Jetstream® CPX-1000 Release Notes

Release 3.2

Document Number 1000-A2-GK41-10
December 2002

New CPX-1000 PDU

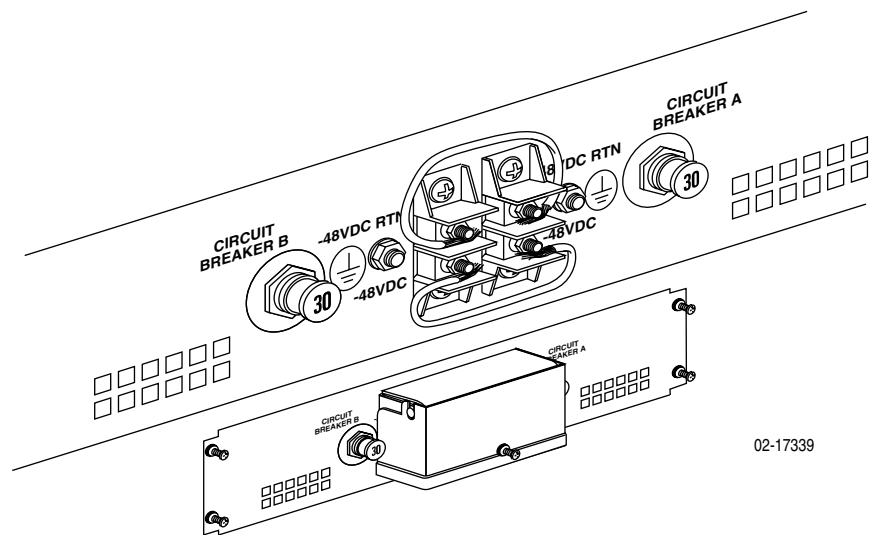
Some models of the CPX-1000 are shipping with a different type of PDU than the one shown in the user documentation.

The new PDU contains two plunger-type circuit breakers instead of one double-pole switch. To remove power from the PDU, pull each circuit breaker plunger out. To apply power to the PDU, push each circuit breaker plunger completely in and release.
